**CITY OF PORTLAND, MAINE  
DEVELOPMENT REVIEW APPLICATION  
PLANNING DEPARTMENT PROCESSING FORM  
DRC Copy**

Single Family Home

- 1 A COPY OF THE NEWLY RECORDED FALL BROOK SEWER EASEMENT SHALL BE DELIVERED TO THE CITY PRIOR TO ISSUANCE OF A CERTIFICATE OF OCCUPANCY.
- 2 Two (2) City of Portland approved species and size trees must be planted on your street frontage prior to issuance of a Certificate of Occupancy.

**PROPOSED LOT SPLIT**  
 FOR A PROPOSED NEW DWELLING  
 32 GERTRUDE AVE. PORTLAND, MAINE

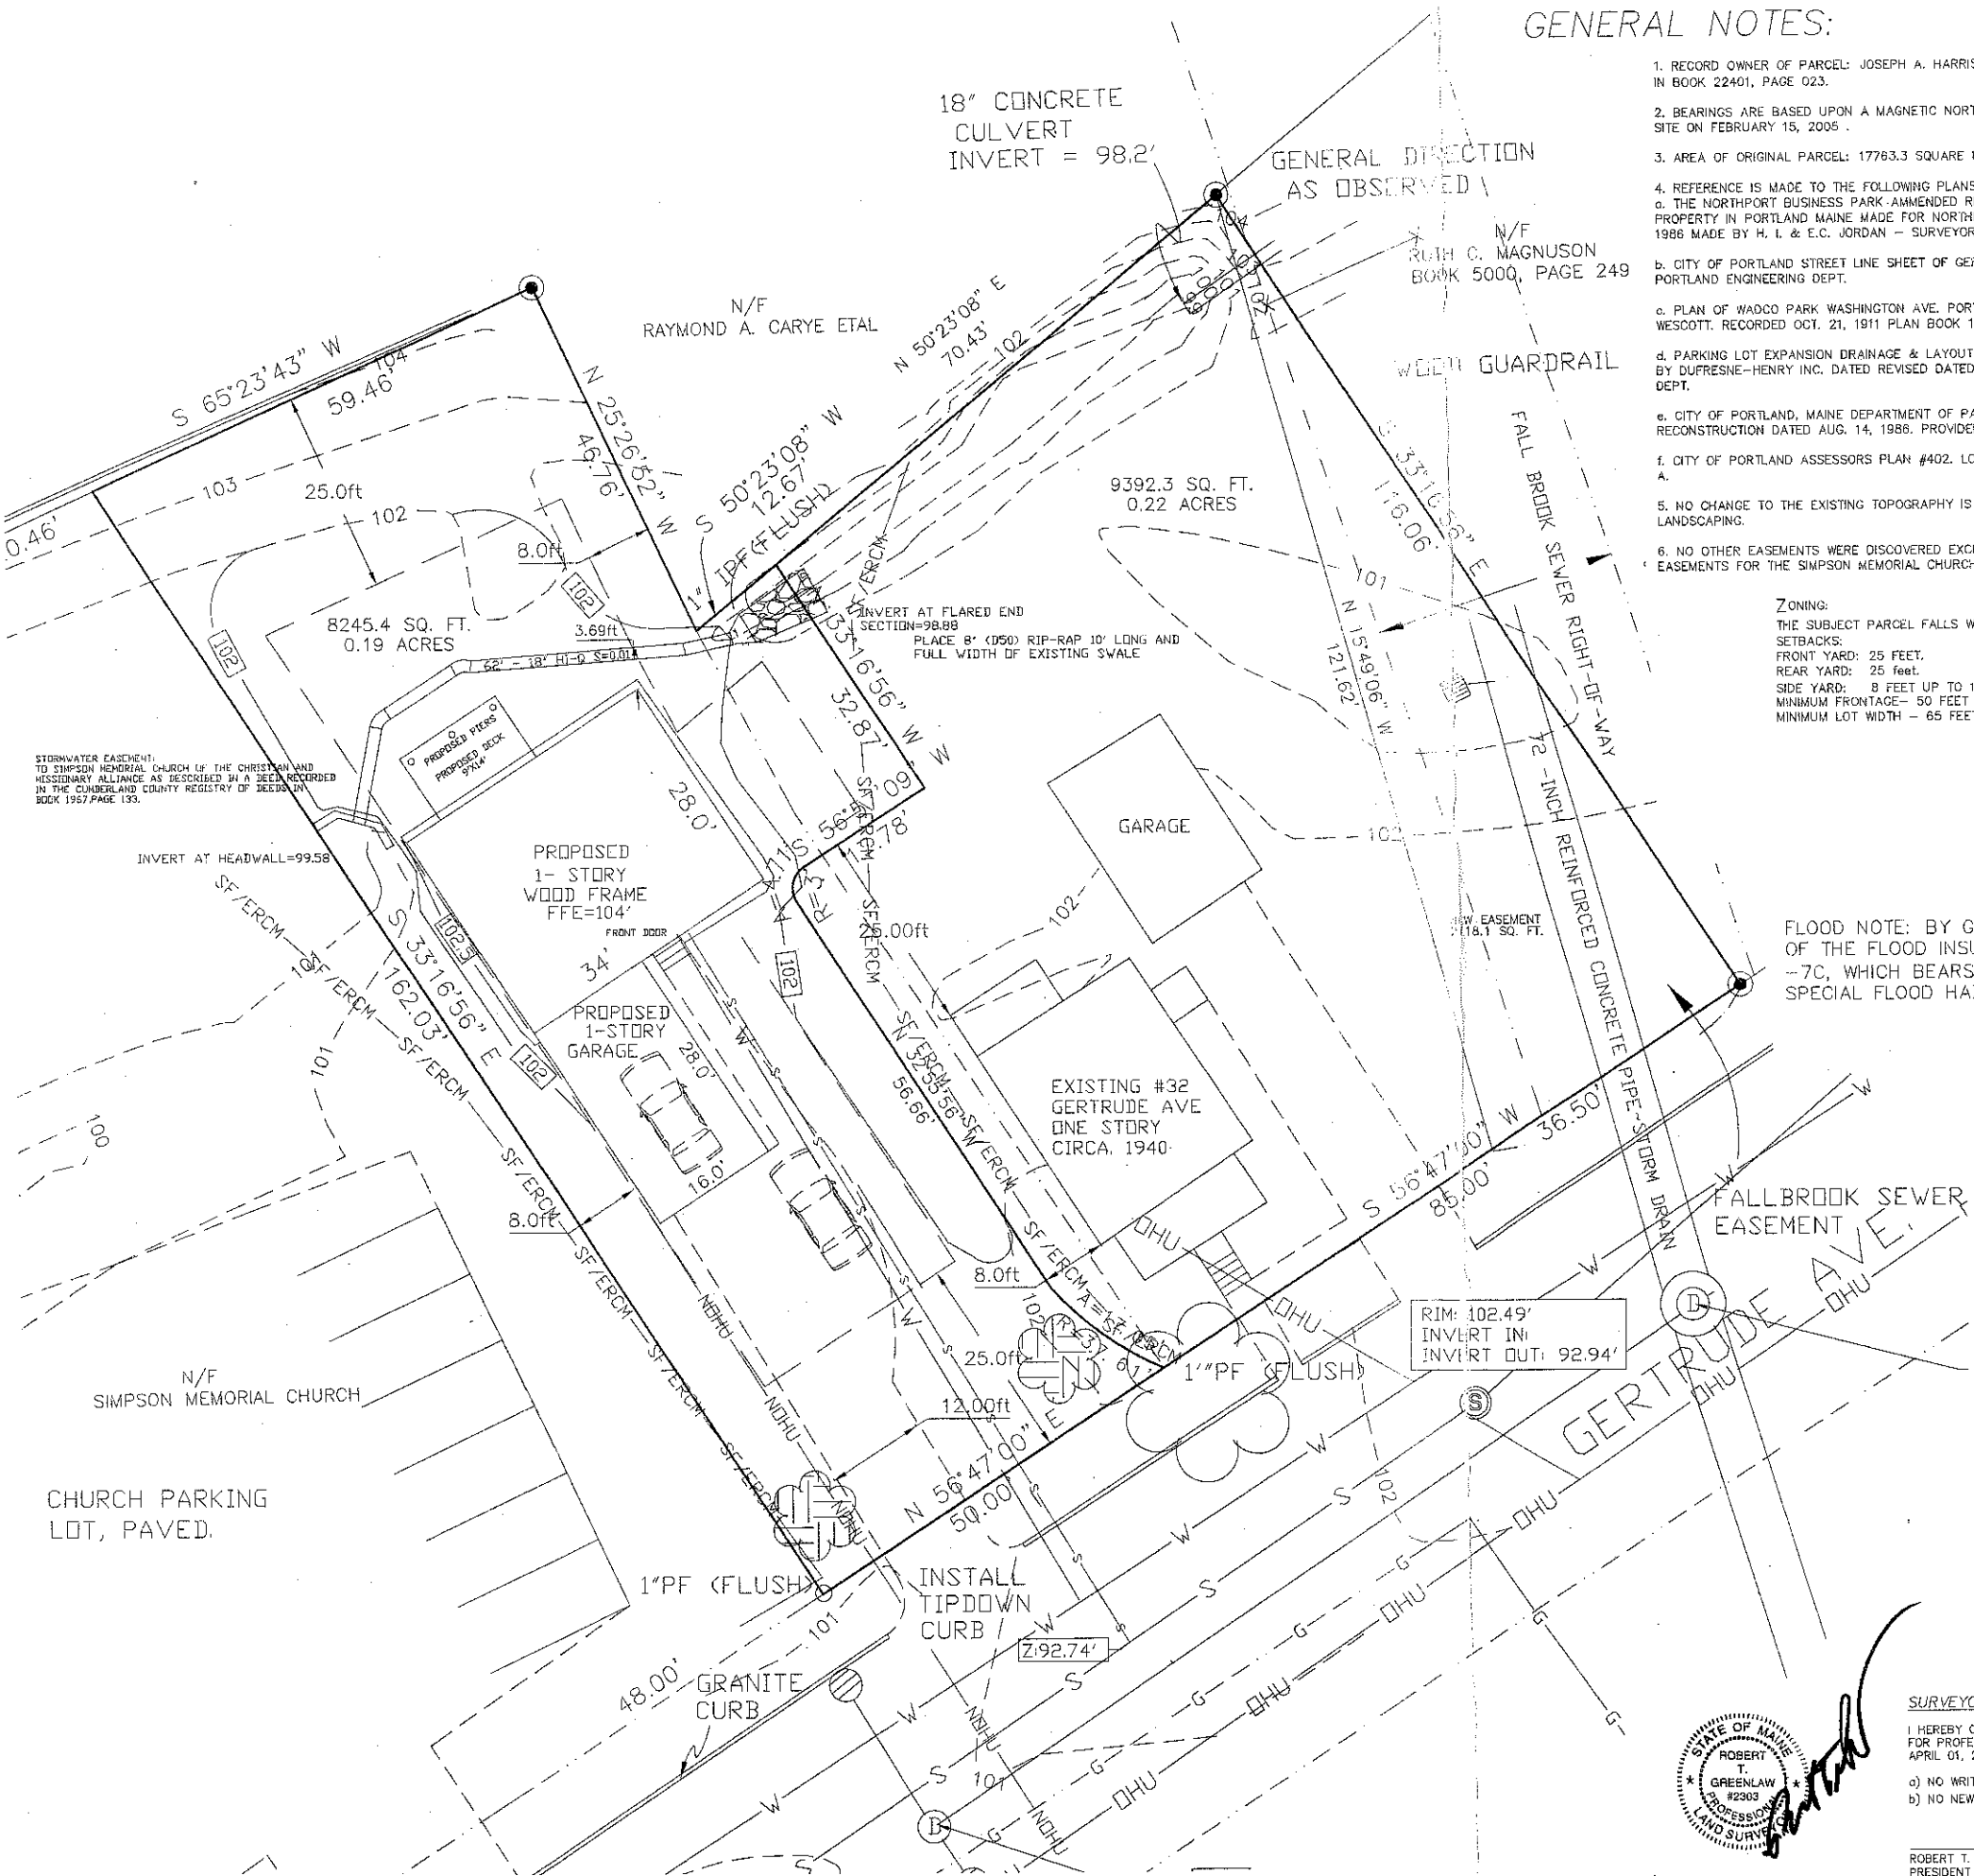
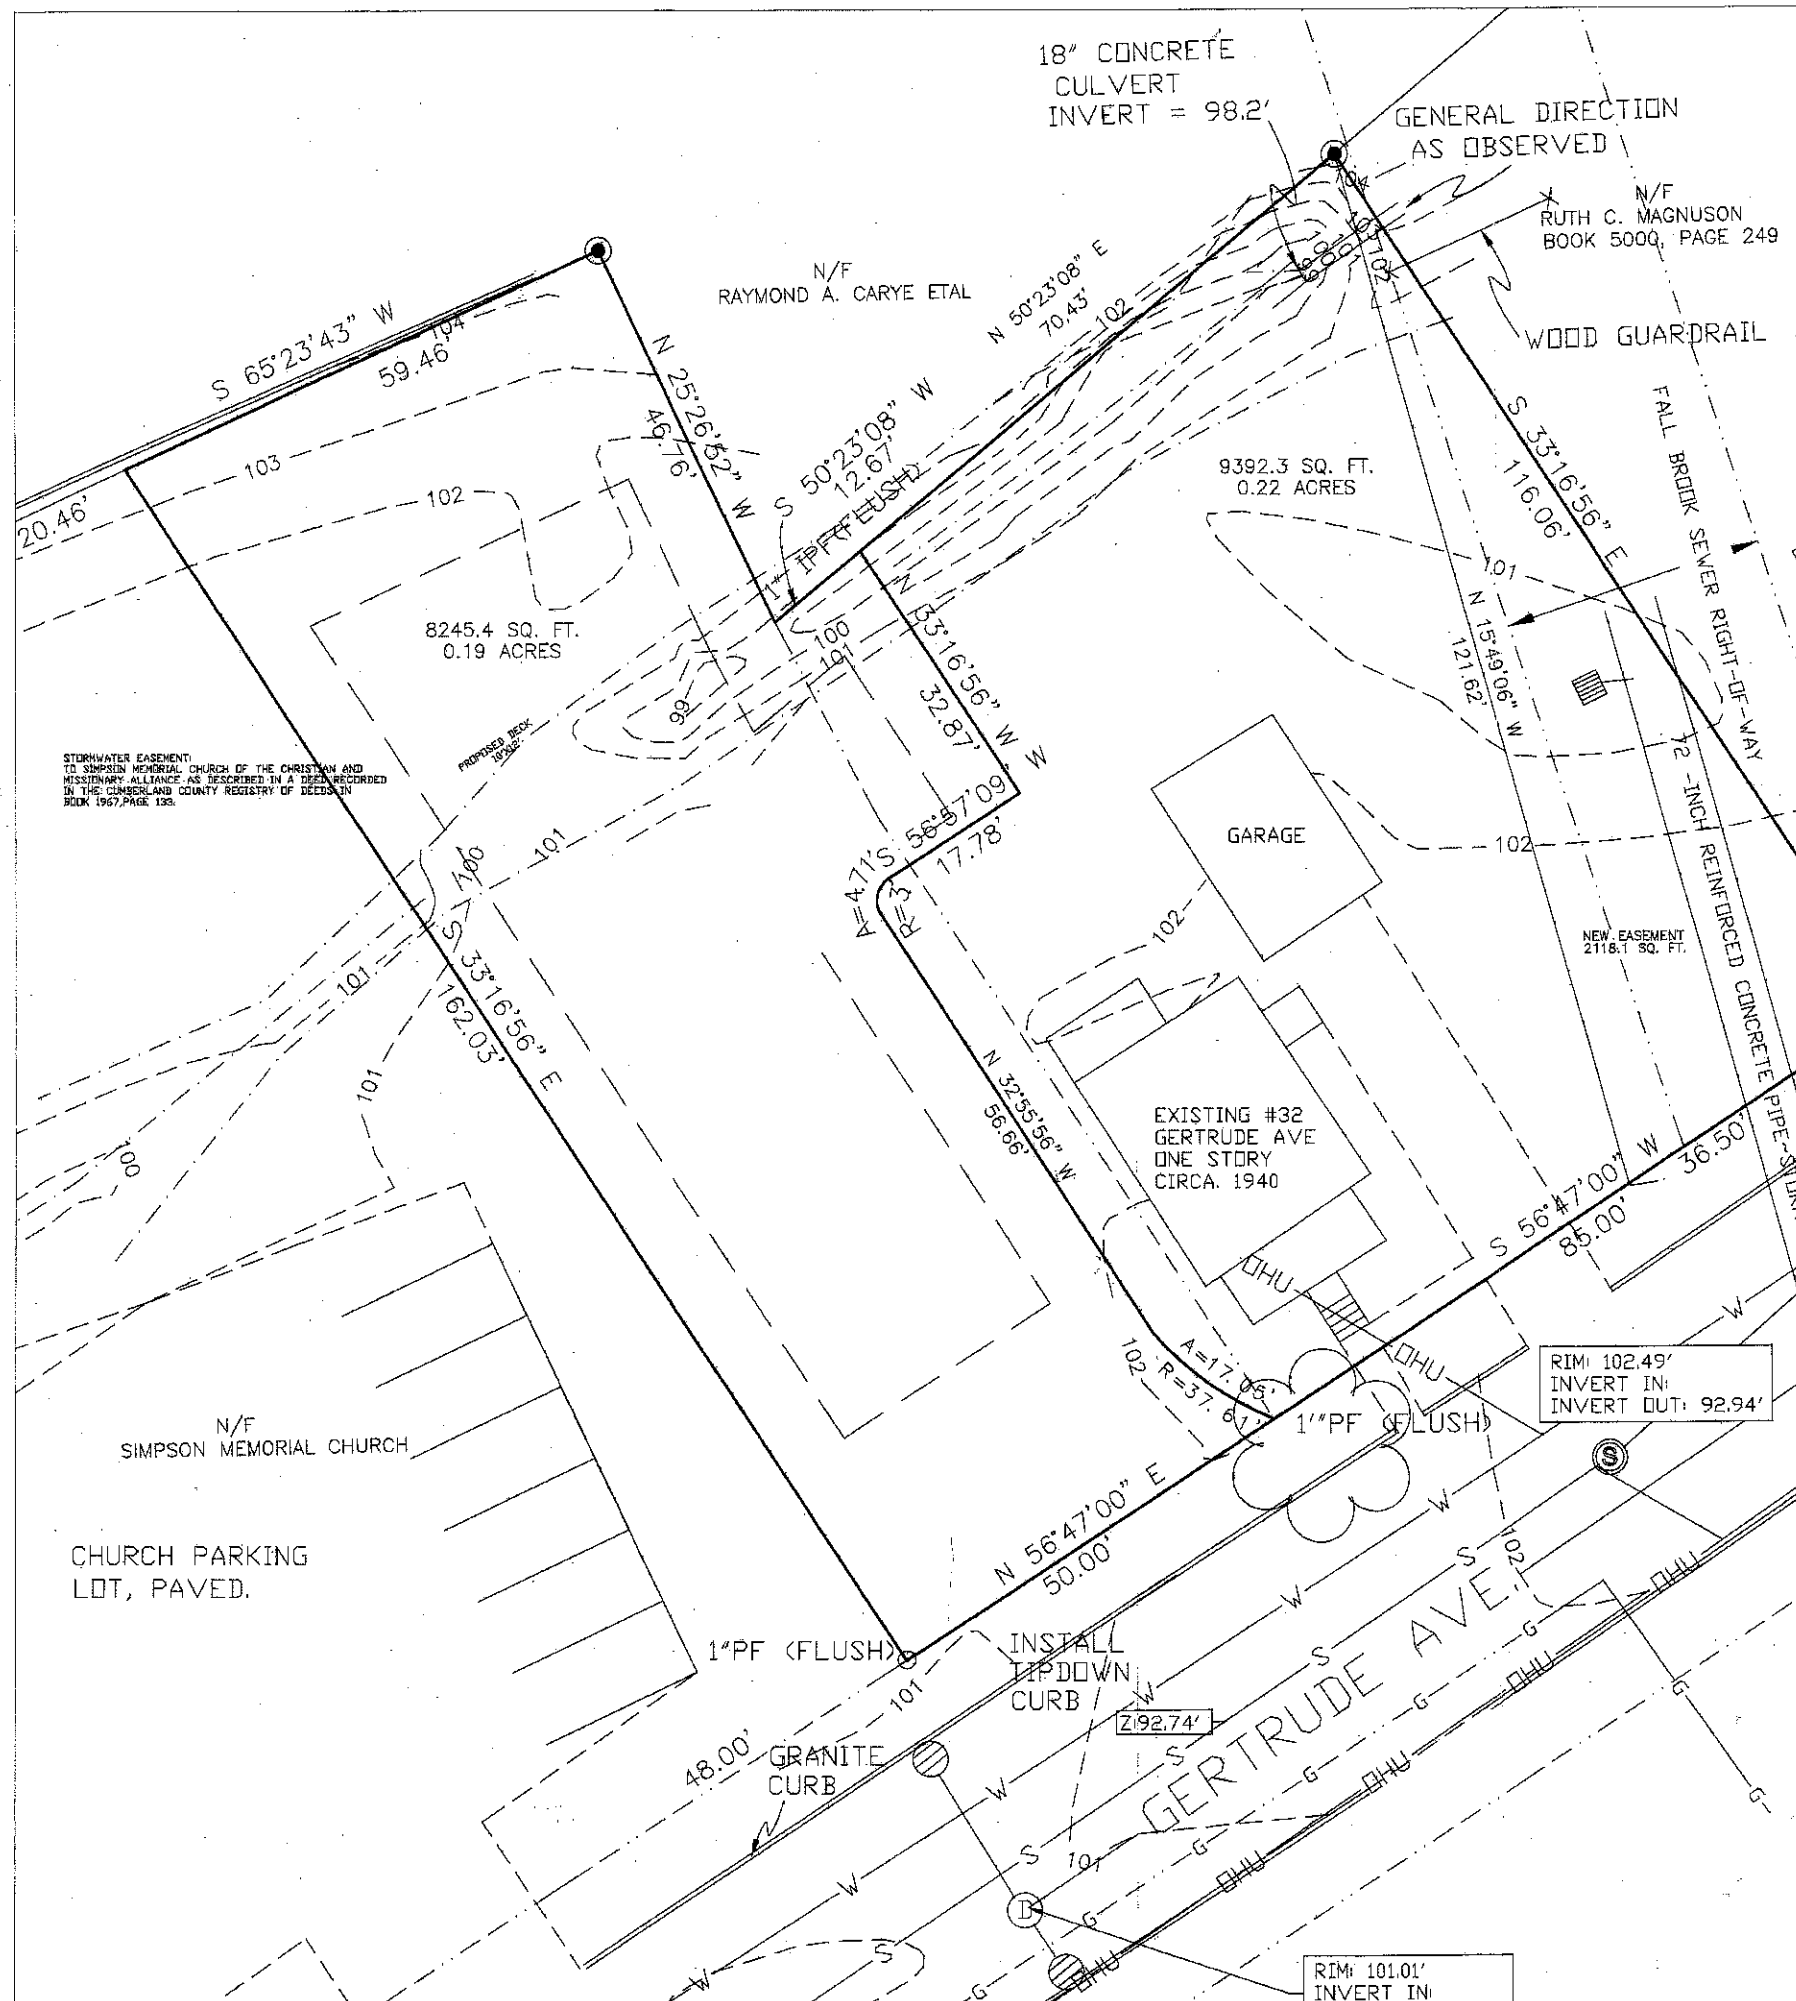
REVISION 06-08-2006: RELOCATED CULVERT TO REAR OF PROPOSED LOT.  
 REVISION: 12-05-2005- RECONFIGURED LOTS
